Response to Comments

**Potlatch Corporation - Lewiston Mill
(NPDES Permit No. ID0001163)**

U.S. Environmental Protection Agency
Region 10

March 8, 2005

Figure 1. Discharge Plume from Individual Ports

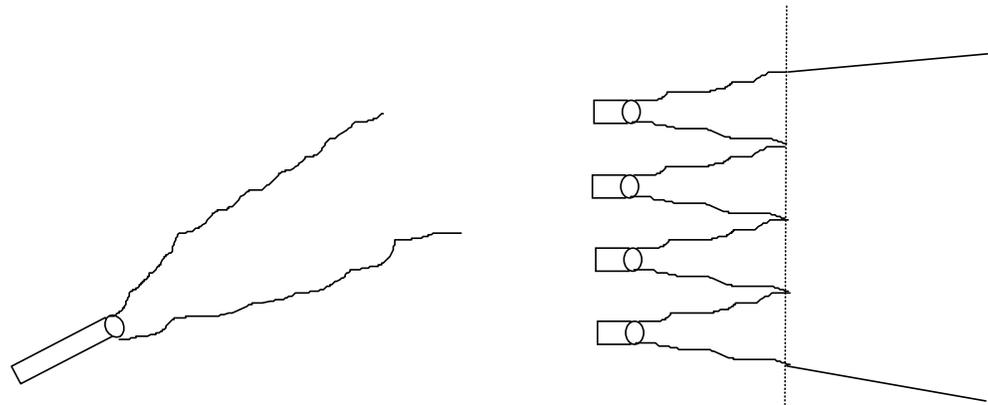
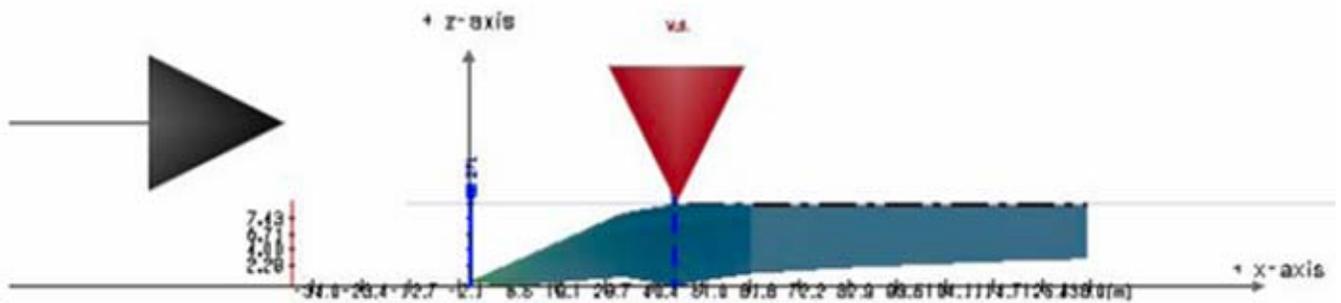
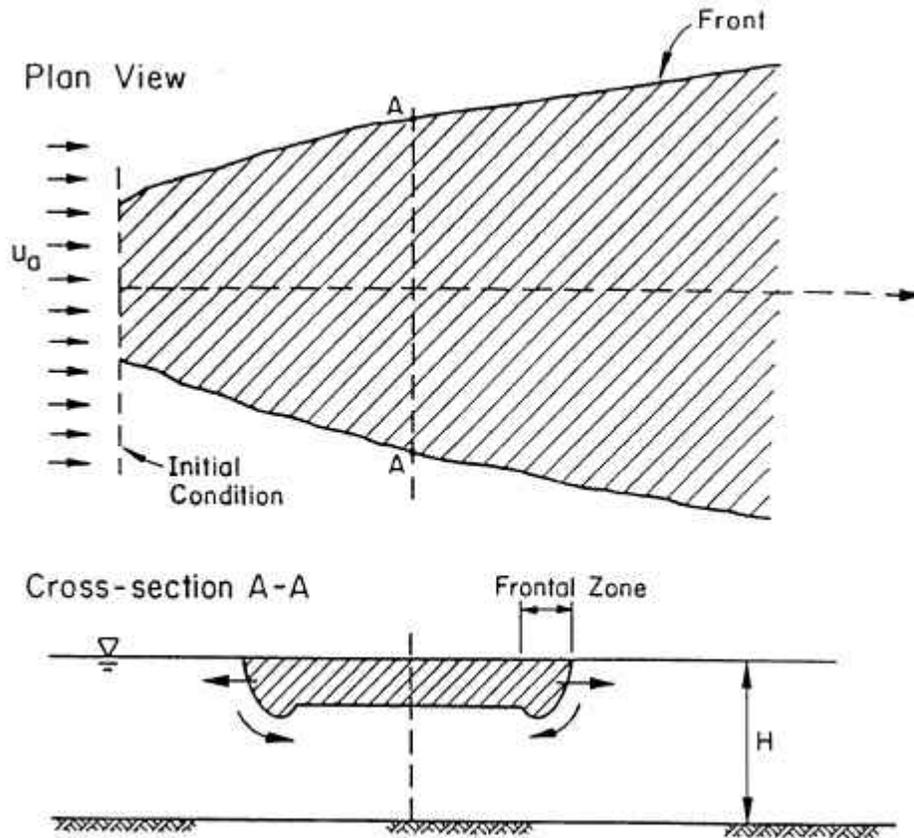
One commentor had several questions regarding the values that were used as input to the mixing zone model. The commentor asked what effluent volume was used in the model, was that volume measured or estimated, and whether the permit includes a flow limit. The commentor also asked what the maximum effluent temperature is, what depth the discharge is, whether there is a diffuser, what shape the plume is, and what are upstream and downstream temperatures at average and minimum flow?

An effluent flow of 40 mgd (62 cubic feet per second) was used in the model to determine the appropriate effluent limitations. EPA had Potlatch conduct a study of their effluent flow capacities in August 2003. The results show that the maximum flow that this system can deliver is 44.6 mgd, although in October 2002 Potlatch ran the system at maximum capacity and only achieved a flow rate of 39.58 mgd. Therefore, for the final permit EPA has rounded this figure and used a flow rate of 40 mgd to determine effluent limitations. No flow limit was incorporated into the draft permit; however, the permit contains loading limits (in lb/day or mg/day) that are calculated based on the maximum effluent flow used to model the dilution.

The maximum effluent temperature reported by Potlatch is 35.2°C (95.4°F). Potlatch discharges at a depth of 9.14 meters below the water surface through a diffuser with 72 active ports. The upstream Snake River temperatures vary throughout the year, so a different upstream temperature was used in the model for each month. The downstream Snake River temperatures at average and minimum flows are either the same as the upstream temperatures or slightly cooler due to Dworshak Dam releases to the Clearwater River.

As the effluent exits the diffuser, the effluent plume resembles 72 small tornadoes with a convex curve (see Figure 1). As the plumes rise and spread, the individual plumes form a plane at a distance of approximately 7 feet downstream of the diffuser that continues to rise to the surface of the water body. The plume reaches the surface of the water body at approximately 34 meters downstream of the diffuser. At this point, the plume is about 3.5 meters thick and 80 meters wide (see Figure 2). The plume will continue to spread (see Figure 3) until it covers the entire width of the Snake River channel. As the cooler water from the Clearwater River also mixes with the Snake River, the plume will be further cooled until an equilibrium temperature is achieved.

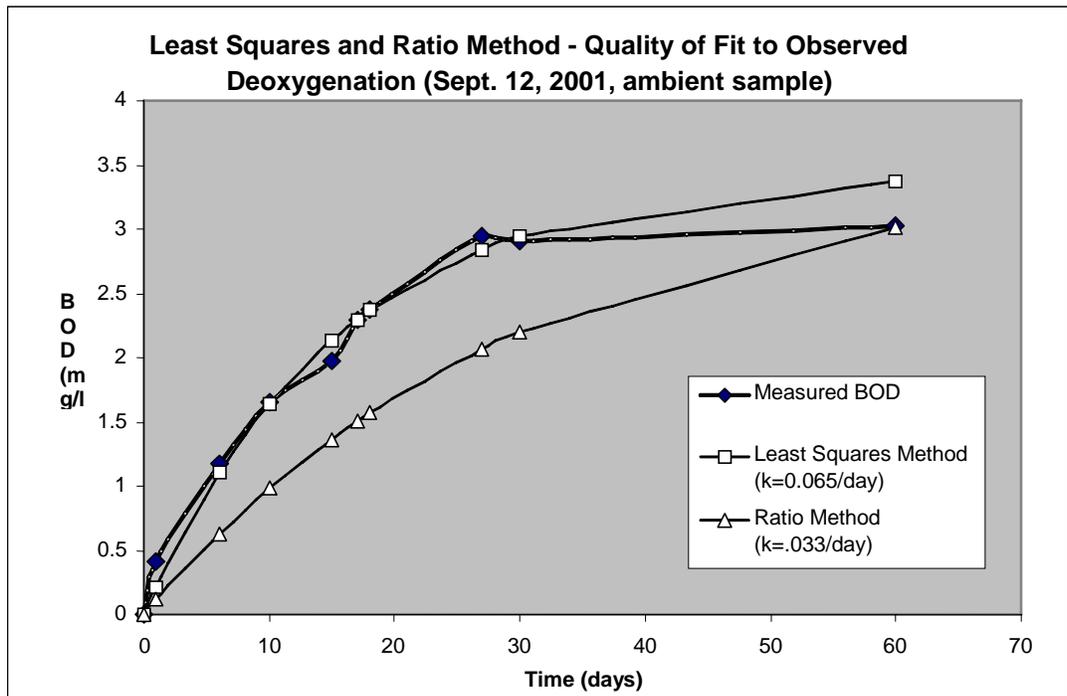
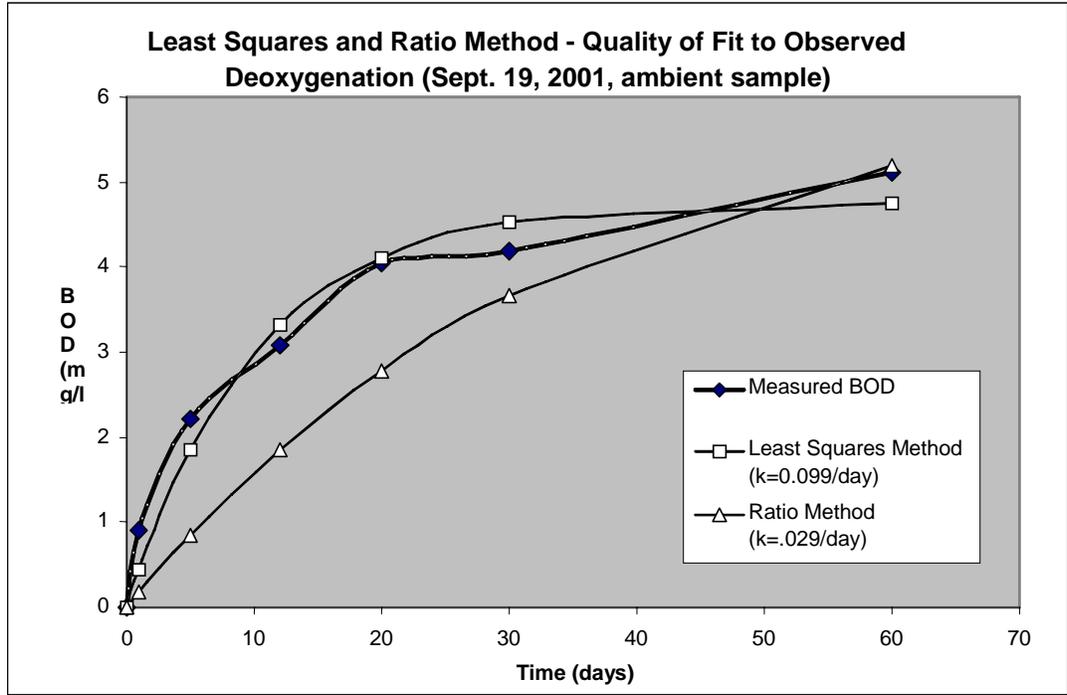
Potlatch commented that EPA calculated limits based on a stated 95% probability threshold, when it is actually a 98.5% probability threshold when one considers the entire

annual record rather than the critical summer season only. The state of Washington used a 90% probability threshold for the Spokane River.
